OREGON STATE UNIVERSITY (OSU)

CHILD CARE CENTER

ADA ASSESSMENT & SURVEY

Re: ADA Accessibility Survey and Assessment – Child Care Center

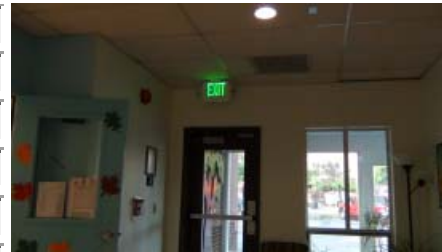
Barrier Description: Carpet, carpet tile or exposed edges of carpet not securely attached or fastened to floor

Findings: Carpet not firmly attached to floor

Rec. Solution: Fasten carpet or tiles firmly to floor. remove or replace

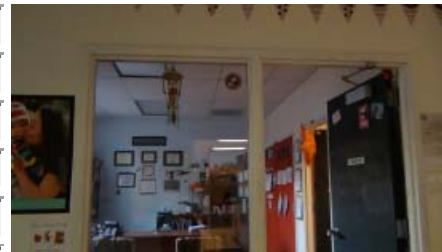
Barrier Description: Horn provided in location where no strobe is provided

Findings: No strobe device provided

Rec. Solution: Provide strobe in common use area

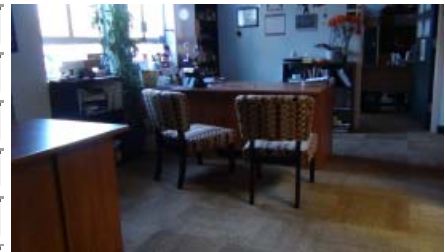
Barrier Description: Door opening force exceeds 5 lbf

Findings: Block lodged between door and frame and no operation measurements could be taken.

Rec. Solution: Provide automatic door opening device

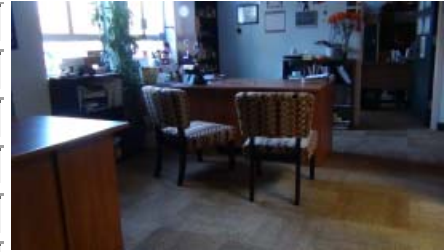
Barrier Description: Knee clearance not min. 27" high, 19" deep or 30" wide

Findings: 26" knee clearance on staff side

Rec. Solution: No remediation recommended for public use

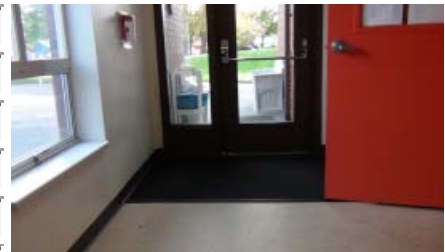
Barrier Description: Doormat not anchored to floor

Findings: Door mat not secured on both sides of door

Rec. Solution: Secure exiting doormat or replace

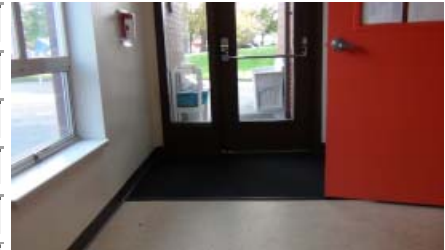
Barrier Description: Door closer lacks min. 5 second sweep period or does not stop 5" from door frame

Findings: 2 second sweep

Rec. Solution: Provide automatic door opening device

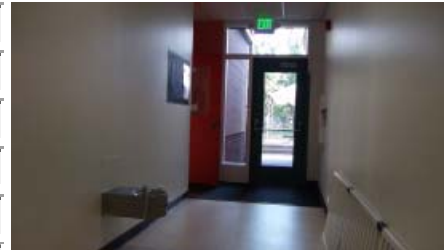
Barrier Description: Horn provided in location where no strobe is provided

Findings: No strobe device provided

Rec. Solution: Provide strobe in common use area

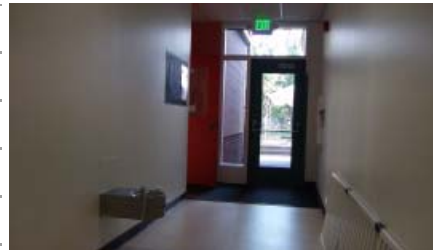
Barrier Description: Door opening force exceeds 8.5 lbf

Findings: 12 lbf at North door

Rec. Solution: Provide automatic door opening device

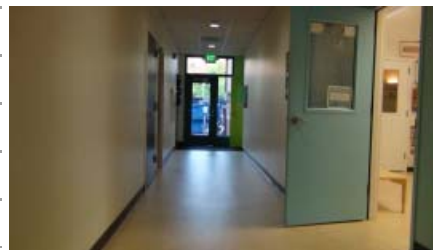
Barrier Description: Exit door leading directly to an exit to the exterior lacks tactile exit sign

Findings: Door leading to exit door to exterior lacks tactile exit sign at North door

Rec. Solution: Provide sign stating "EXIT ROUTE" at exit side of door

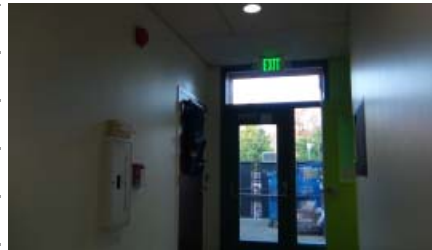
Barrier Description: Use of outlet involves low reach of less than 15" above floor or more than 48" high

Findings: 12" high

Rec. Solution: Relocate outlet to area at min. 15" or max. 48" high

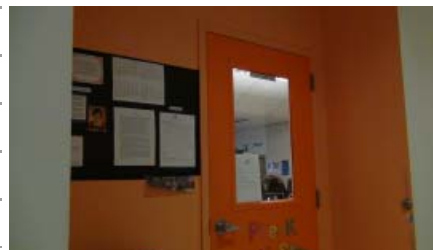
Barrier Description: Knee clearance of at least 27" high, 30" wide and 8" deep not provided underneath desk

Findings: Planter boxes 13-1/2" knee clearance

Rec. Solution: Reposition desk to provide knee clearance

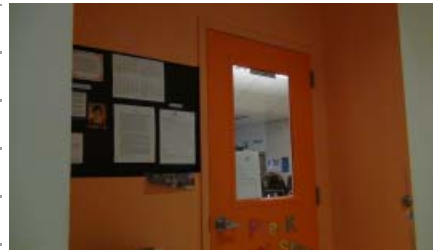
Barrier Description: Door/Gate at pull side with min. 60" lacks min. 18" strike edge clearance at pull side

Findings: No strike edge clearance

Rec. Solution: Remove table

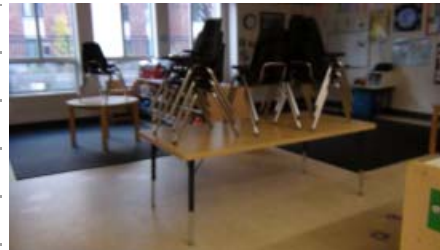
Barrier Description: Knee clearance not min. 27" high, 19" deep or 30" wide

Findings: 17-1/2" knee clearance at blue table in Art area

Rec. Solution: Provide min. 1 accessible table. Avoid pedestal base tables.

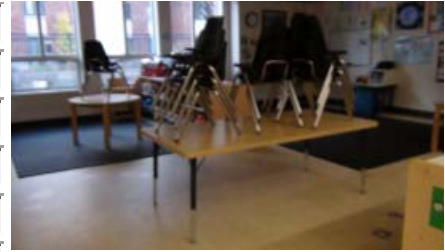
Barrier Description: Knee clearance of at least 27" high, 30" wide and 8" deep not provided

Findings: Easel in Art area has no knee clearance

Rec. Solution: Provide min. 1 accessible workstation of each type or overall 5%

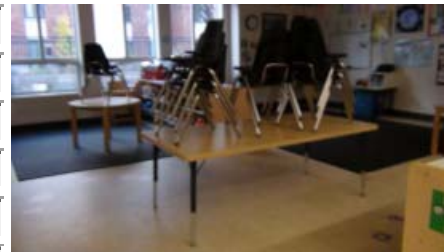
Barrier Description: Knee clearance not min. 27" high, 19" deep or 30" wide

Findings: Central rectangular tables X 3 with 19" kn cl in classroom area, but they may be adjustable.

Rec. Solution: Provide min. 1 accessible table. Avoid pedestal base tables.

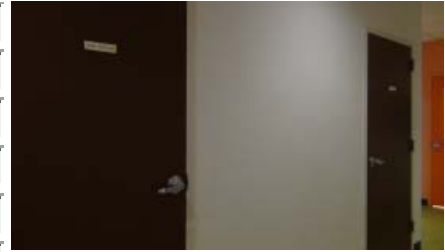
Barrier Description: No horn/strobes in common use areas

Findings: No device provided

Rec. Solution: Provide strobe in common use area

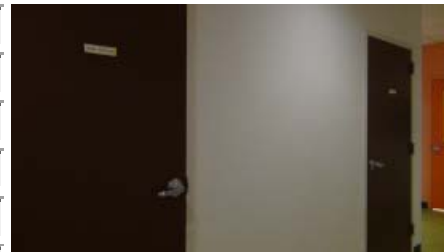
Barrier Description: No ISA symbol on wall sign posted at accessible toilet room

Findings: No ISA sign identifying restroom as accessible

Rec. Solution: Provide ISA symbol on restroom wall sign

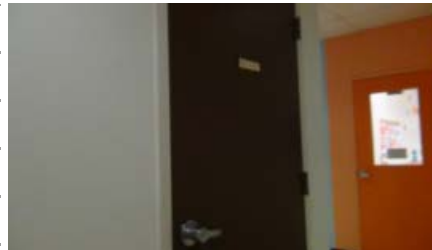
Barrier Description: Where a fire alarm is installed, no horn/strobe provided

Findings: No device provided

Rec. Solution: Provide horn/strobe in sanitary facility

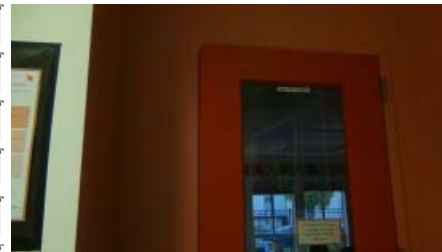
Barrier Description: No tactile characters at sign identifying permanent rooms and spaces with visual signs

Findings: No tactile signage provided at door within public route

Rec. Solution: Provide accessible sign

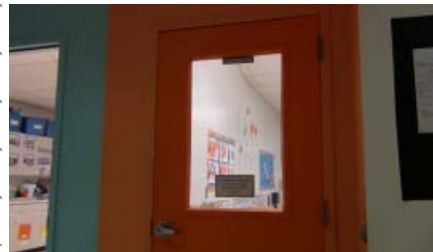
Barrier Description: No horn/strobes in common use areas

Findings: No device provided

Rec. Solution: Provide strobe in common use area

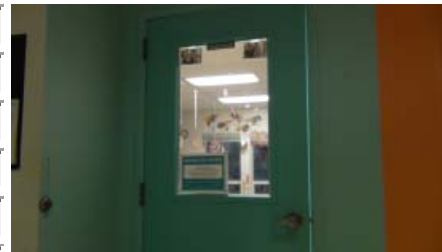
Barrier Description: Door or gate lacks landing on both sides of door

Findings: 2.6% slope

Rec. Solution: Demolish and reconstruct level landing

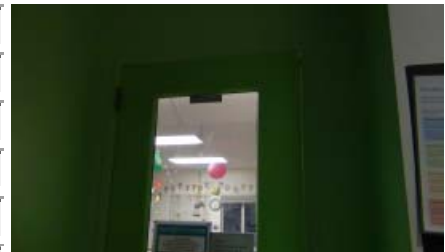
Barrier Description: Door/Gate at pull side with min. 60" lacks min. 18" strike edge clearance at pull side

Findings: 11-1/2" - 14-1/2" strike edge clearance

Rec. Solution: Relocate door or gate to provide maneuvering clearance

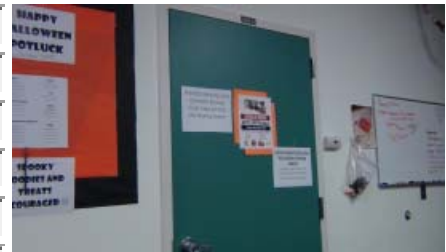
Barrier Description: Door opening force exceeds 5 lbf

Findings: 12 lbf

Rec. Solution: Provide automatic door opening device

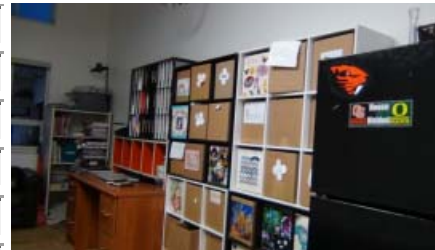
Barrier Description: Outlet located over an 10" to 24" obstruction max. 34" high located above 46"

Findings: Outlets above counter 44" high and 25" deep over counter

Rec. Solution: Relocate control or mechanism to max. 46" high

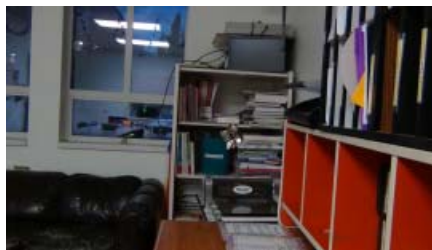
Barrier Description: Use of control involves low reach of less than 15" above floor or more than 48" high

Findings: Cubbies above 48" high

Rec. Solution: Provide assistance as needed

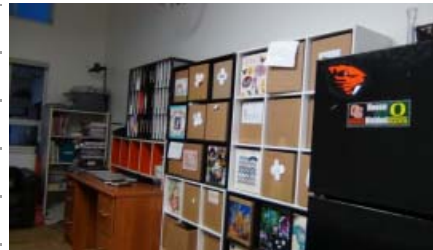
Barrier Description: Mailbox opening is above 48" high

Findings: Mailbox above 48" high

Rec. Solution: Provide assistance as needed
